Certified Action of the City of Raleigh Planning Commission

Case File / Name: SP-22-12 / 2604 Hillsborough Street

Staff Report

SP-22-12 / 2604 Hillsborough Street – Preliminary Site Plan

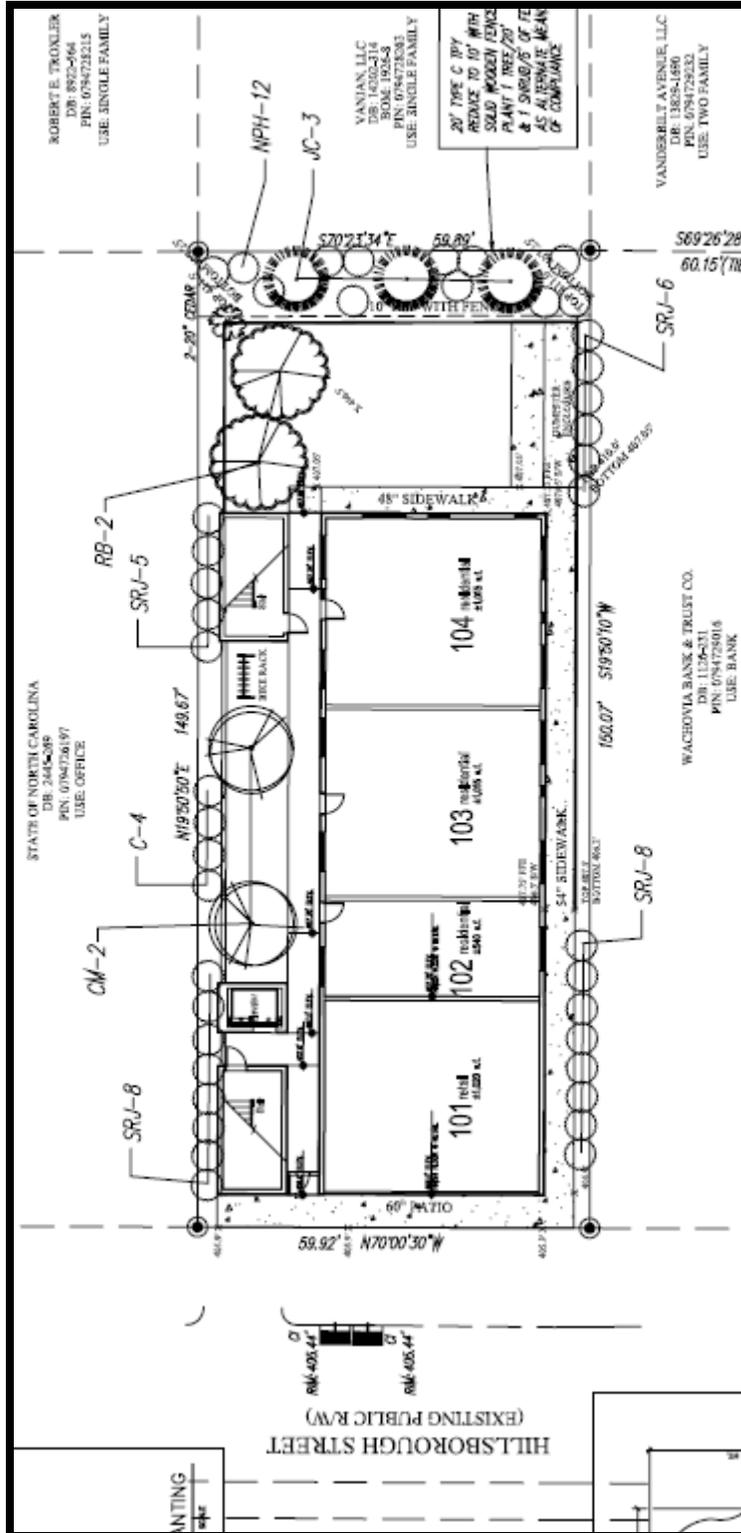
2. Given the pedestrian context and setback, continue the use of ground floor glass commercial storefront on the east façade to provide visibility to the commercial space and to soften the eastern façade. [commensurate with Code Sec. 10-2132.2(d)(6)].	A glass storefront opening will be added to the east side of the first floor retail space consistent in size with openings at the (3) floors directly above.

3. Given the prominence of the site and the nature of student housing, the applicant should use quality, durable materials [commensurate with Code Sec. 10-2132.2(d)(6)].	Quality, durable materials will be utilized, particularly at ground level areas subject to pedestrian contact.

4. Consider keeping the large address numbers as signage should they be permissible under the City’s sign ordinance [commensurate with Code Sec. 10-2132.2(d)(6) and 10-2083.1(c)(2) f.]	The use of large address numbers as the building signage provide identity while aiding with way finding and will be considered pending evaluation and compliance with the City’s sign ordinance.
